Proposed Residential Development at Carley's Bridge, Enniscorthy: Traffic and Transport Assessment

For Torca Developments Limited

Final Report

April 2022

Figure 2: Proposed Site Access and Scope of Audit

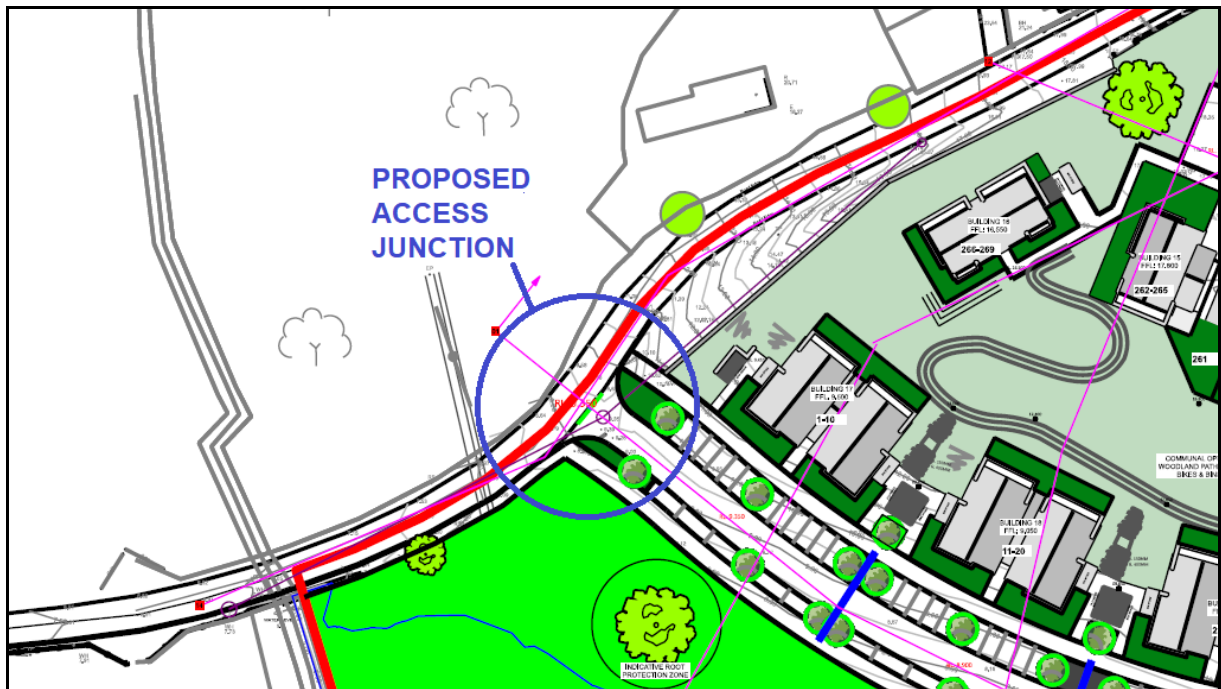
- 1.1 This report results from a Stage 1 Road Safety Audit (RSA) of the proposed access to a new residential development off Carley's Bridge Road in Enniscorthy, Co Wexford, carried out at the request of Transport Insights Limited. The Carley's Bridge Road is a relatively narrow single carriageway local road (L2039) with no road markings, footways, drainage or street lighting, and narrow or absent verges, hence is rural in characteristic. The site will be accessed via a priority controlled T junction at the location shown in figure 1, and the site development will involve construction of 266 residential units. This Audit examines the road safety implications associated with the proposed access to the development only, as highlighted in figure 2, and does not include an audit of the internal site layout.

Figure 3: Collision Plot for Road network adjacent to site

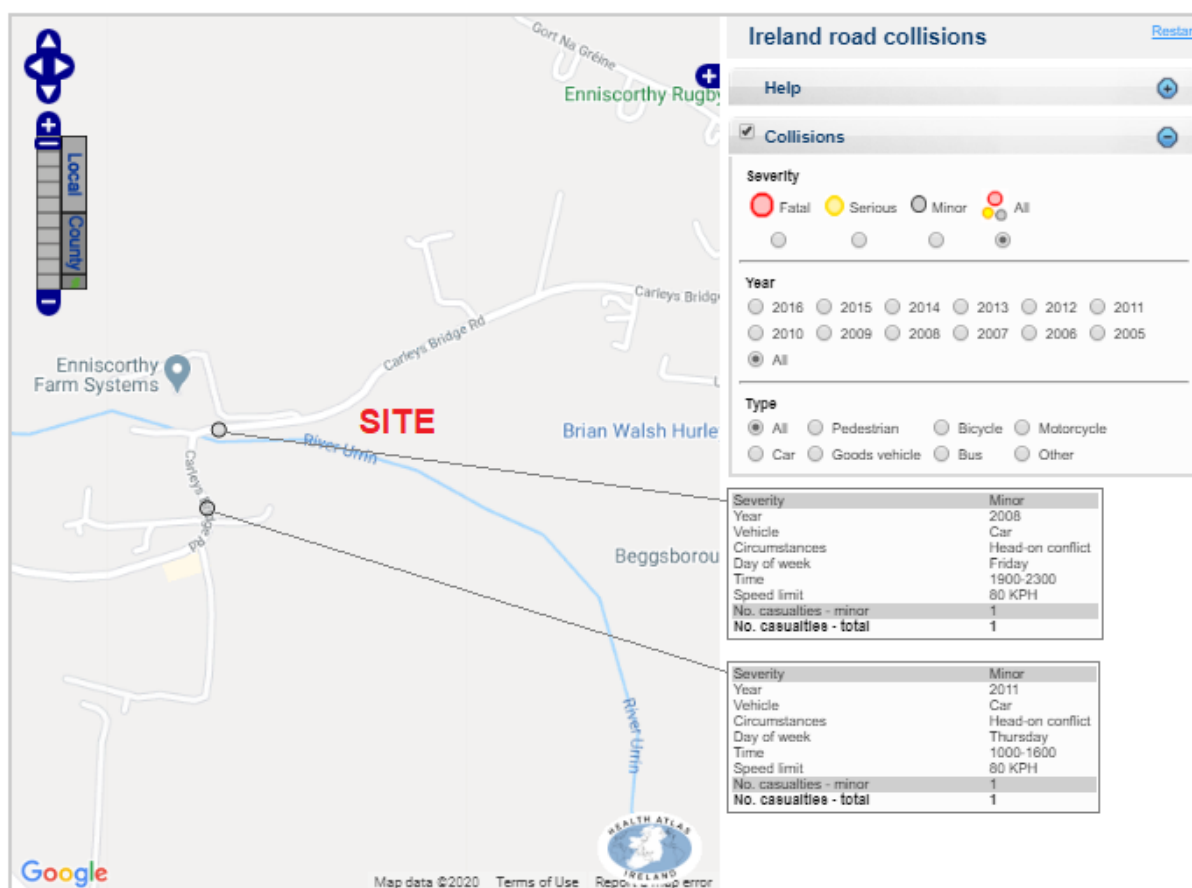
2.1.3 No information was provided on any existing collision statistics in the vicinity of the site. A review of the Road Safety Authority (RSA) online collision database indicates that there were two minor collisions recorded on L2039 to the west of the proposed development site between 2005 and 2016 inclusive, as shown in figure 3. Both collisions involved a head on conflict, which is likely to be reflective of the narrow carriageway and poor stopping sight distance (SSD) arising from back to back curvature on the link at present.

Figure 4: Eastbound approach to site access showing speed limit changeover

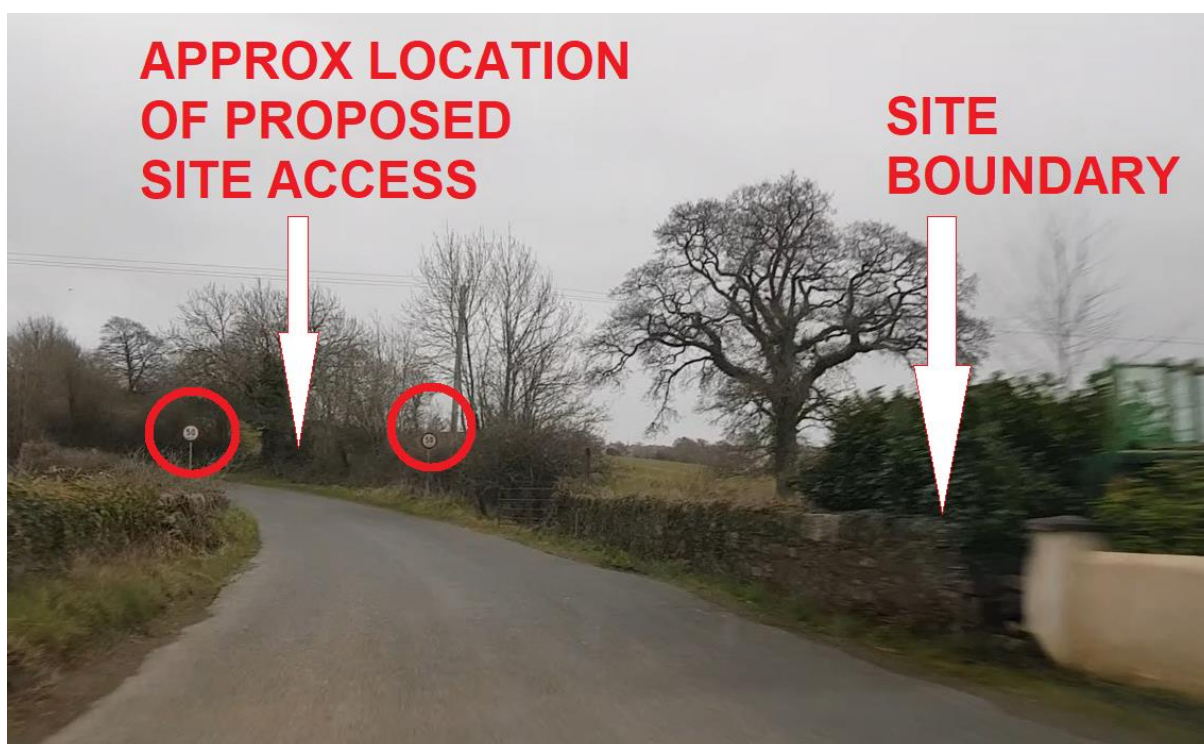
The speed limit on the local road adjacent to the site is split between the 80 km/hr rural speed limit and the 50 km/hr urban speed limit, with the proposed site access located approximately 20m east of the speed limit changeover, as shown in figure 4.

Figure 6: Parking close to proposed Access Junction

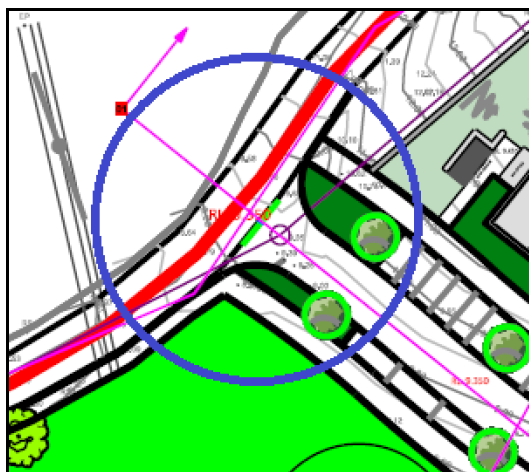
It was noted that perpendicular and parallel parking spaces have been provided to each side of the access road into the site in relatively close proximity to the proposed access junction, as shown in figure 6. Visibility towards vehicles pulling out of these spaces, particularly those reversing from the perpendicular spaces, is likely to be compromised by the proposed landscaping shown on the plan at this location. Vehicles reversing out of these spaces may also obstruct the path of entering vehicles, leading to an increased risk of blocking back onto the major road, and an increased risk of rear shunt or right angled collision.

Figure 9: Discontinuous footway at Junction

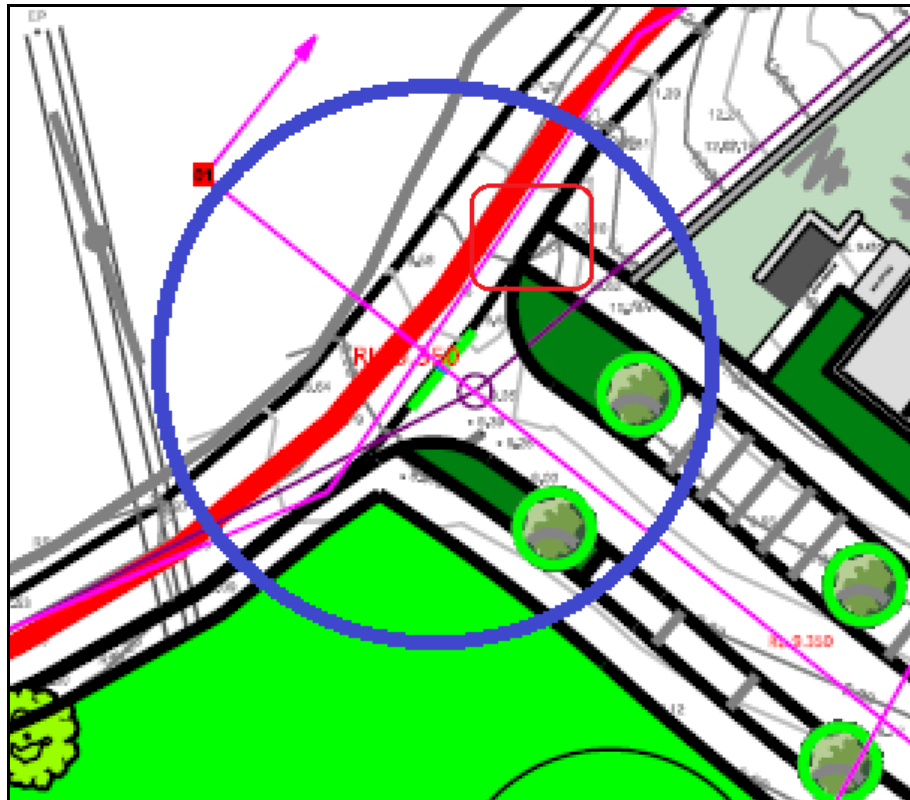
Footways have been provided to each side of the minor road access into the site, however the footway on the eastern side terminates abruptly, as shown in figure 9, and there is no provision for safe pedestrian continuity. Pedestrians wishing to travel between the site and the centre of the town of Enniscorthy, located approximately 1.5km east of the site, will be vulnerable at this location, where there is no provision for footways at present on either side of the carriageway at a location where SSD is limited by the current cross section, boundary treatment, and horizontal and vertical alignment curvature. A narrow footway appears to have been provided along the site boundary to the southwest of the access junction, however continuity of the footway beyond the site boundary is unclear.

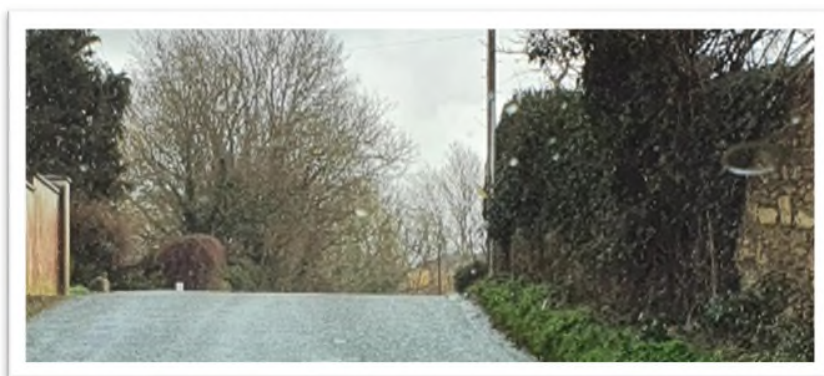
Drawing – 2020 C543_1/1 v1.5, Pedestrian crossing.

It is recommended that the stopping sight distance be checked in both directions based on the operating speed of Carley's Bridge Road.

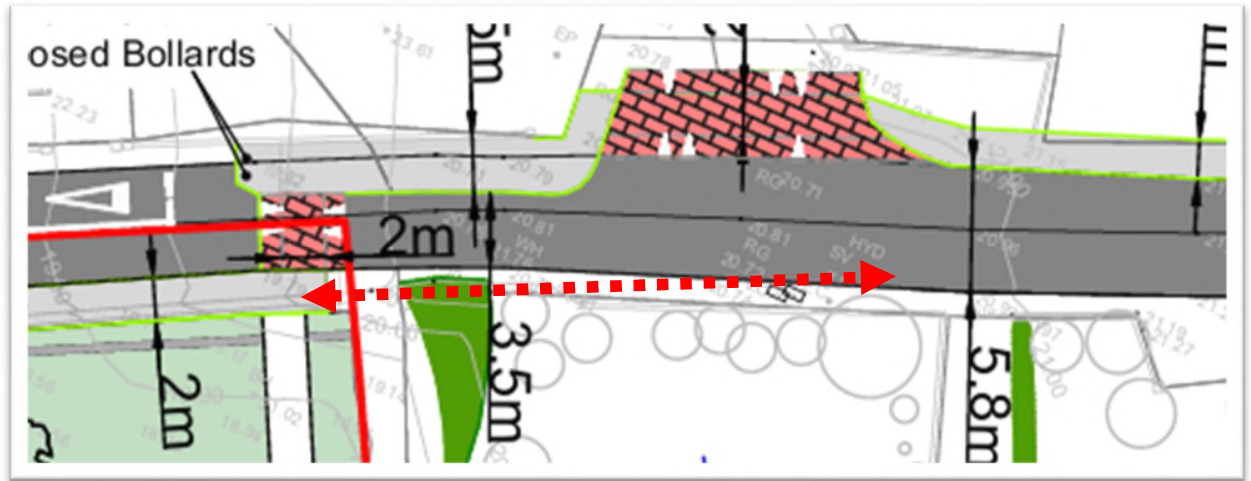
Drawing – 2020 C543_1/1 v1.5, Pedestrian crossing.

Ensure suitable inter-visibility is provided.

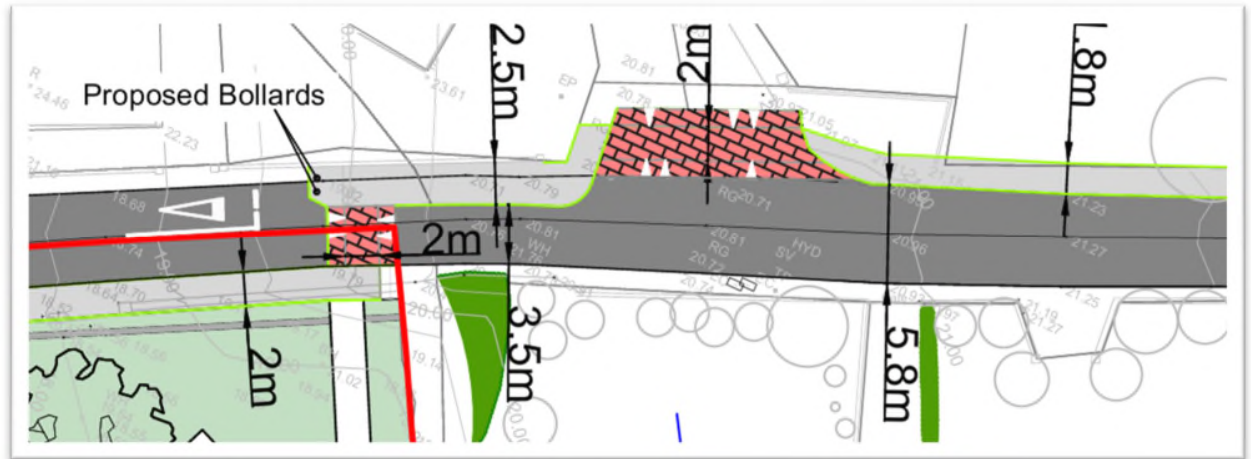
Drawing – 2020 C543_1/1 v1.5, Shuttle System.

It is recommended that a Stop/Yield system be provided instead of the yield priority system with a yield line and triangle provided on the eastern side of the shuttle system. The location of the yield line should take into account right turning traffic from the Potters Way residential development.

Drawing No. 2020 C543_1 /1 v1.5
Drawing Road Design - Raised Crossing
Status Concept Design
Client Torca Developments Limited

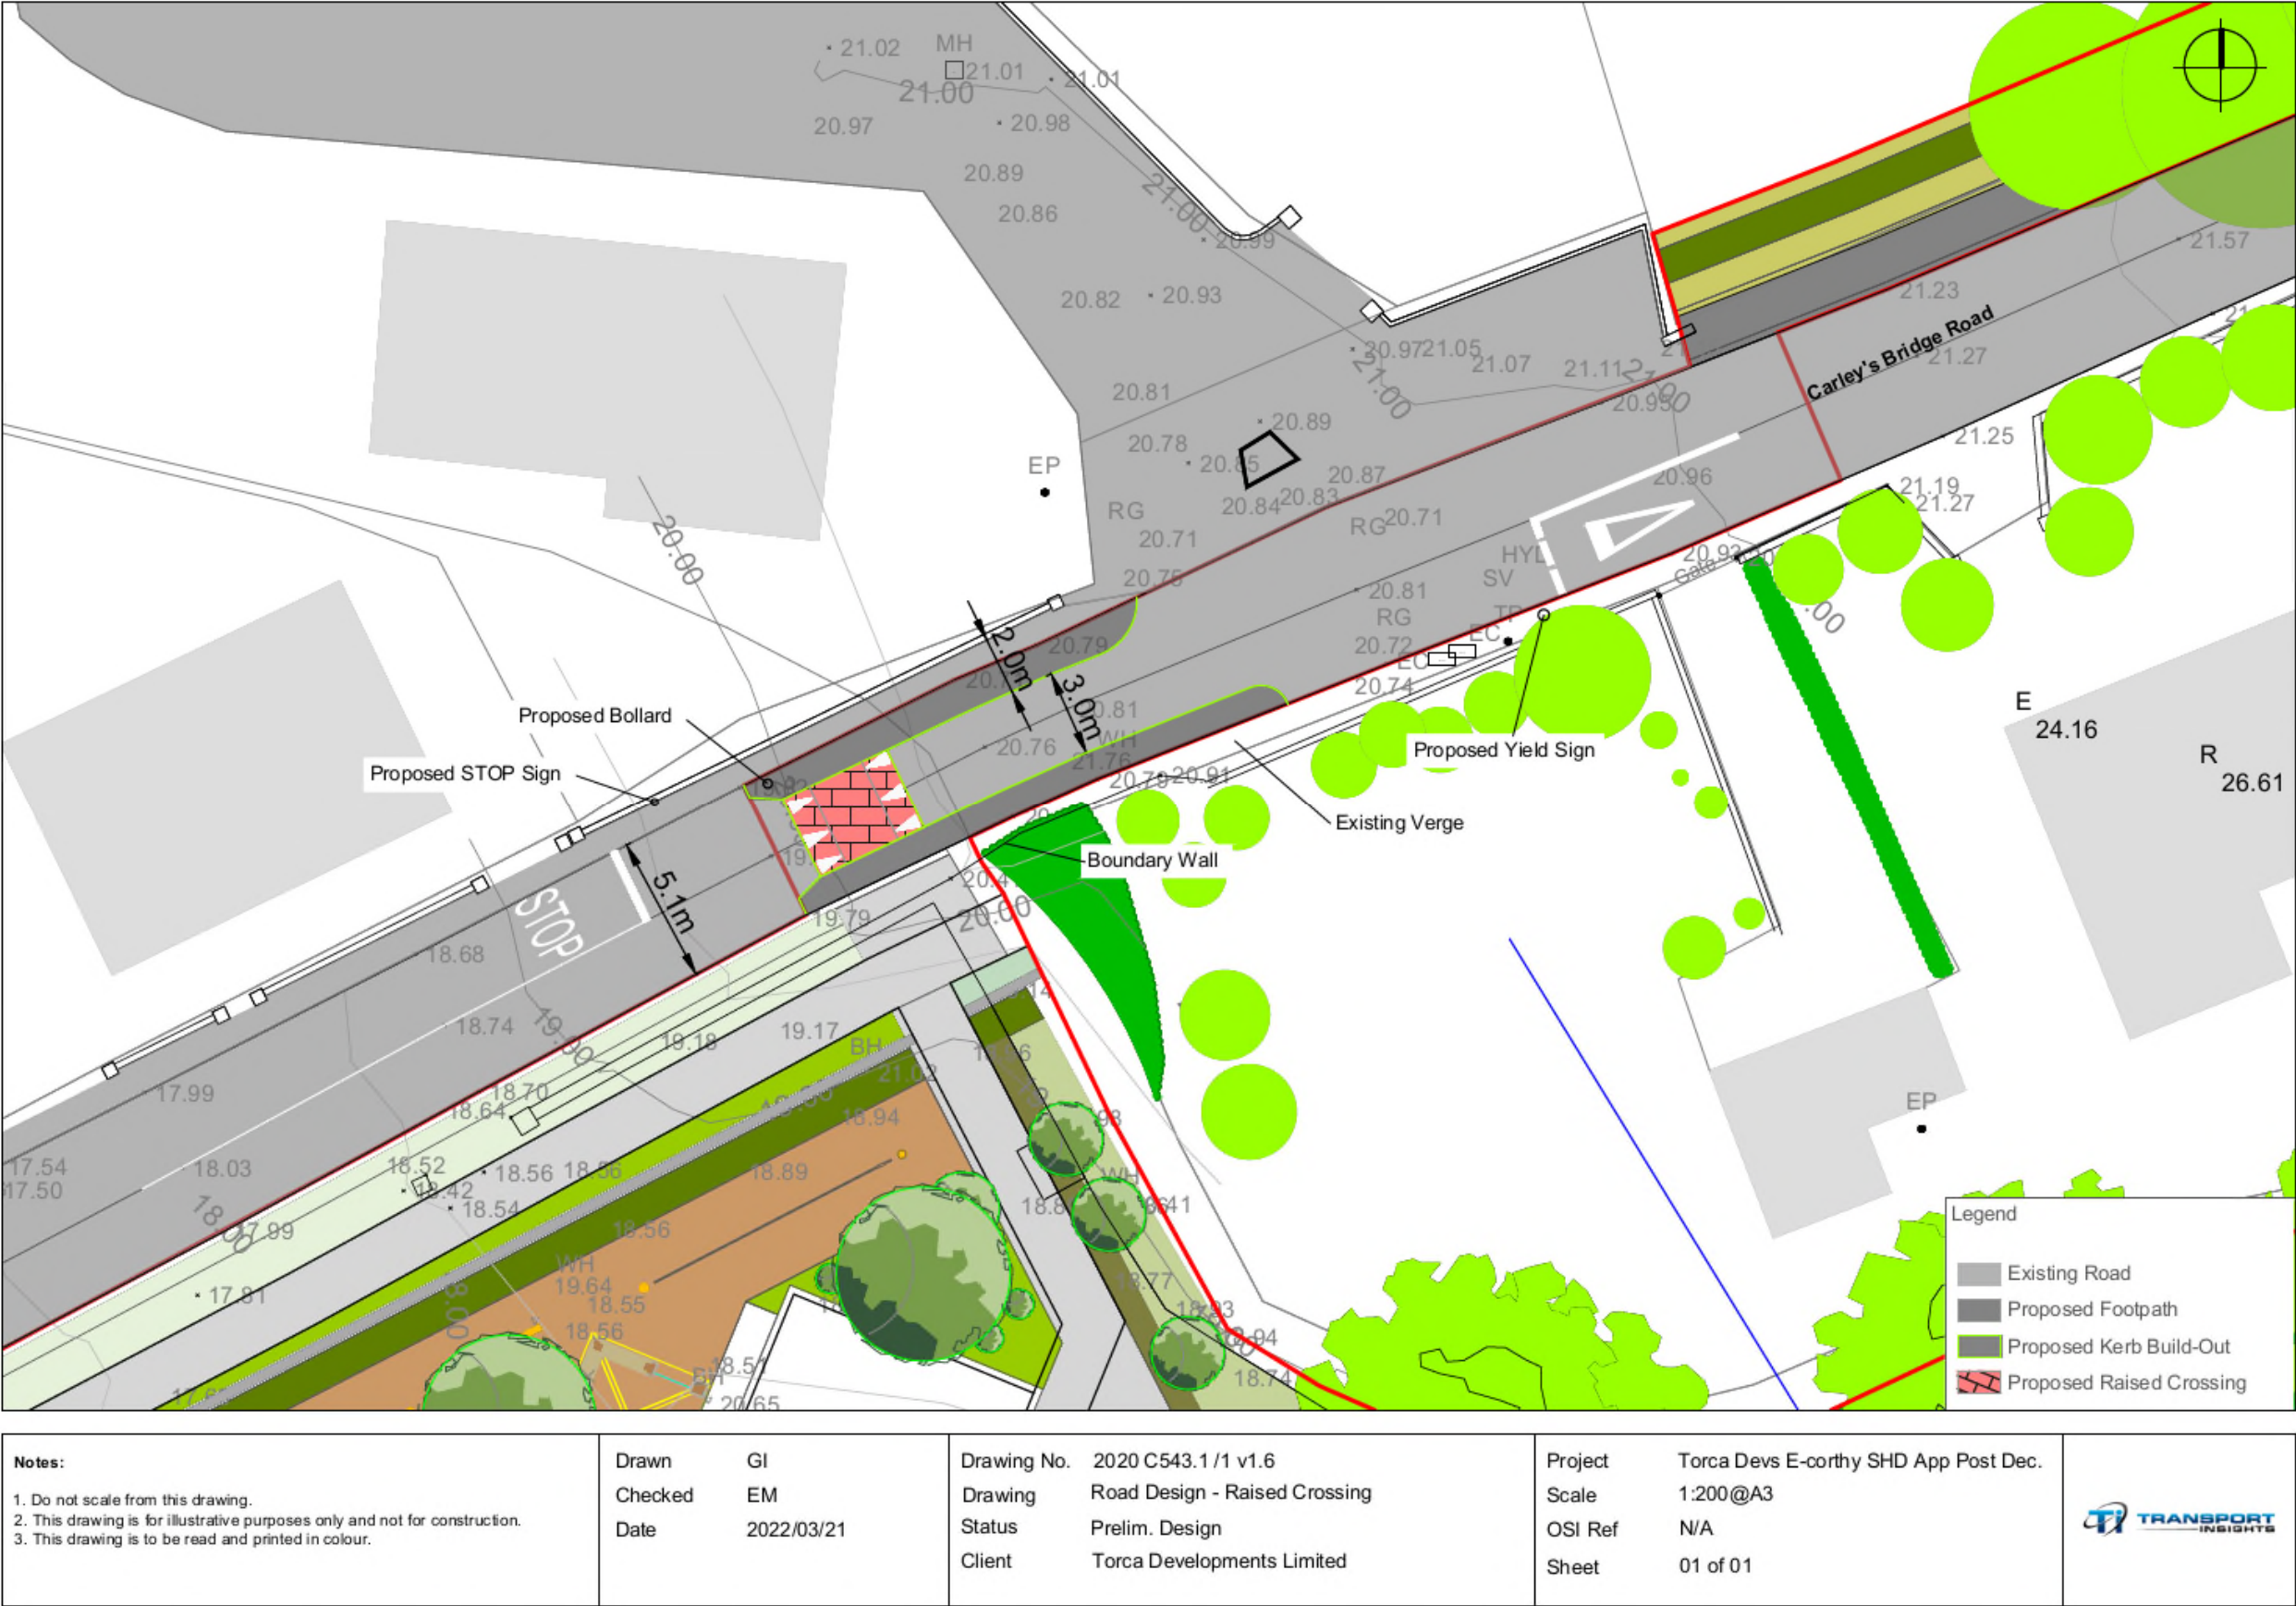
Problem Location Plan.
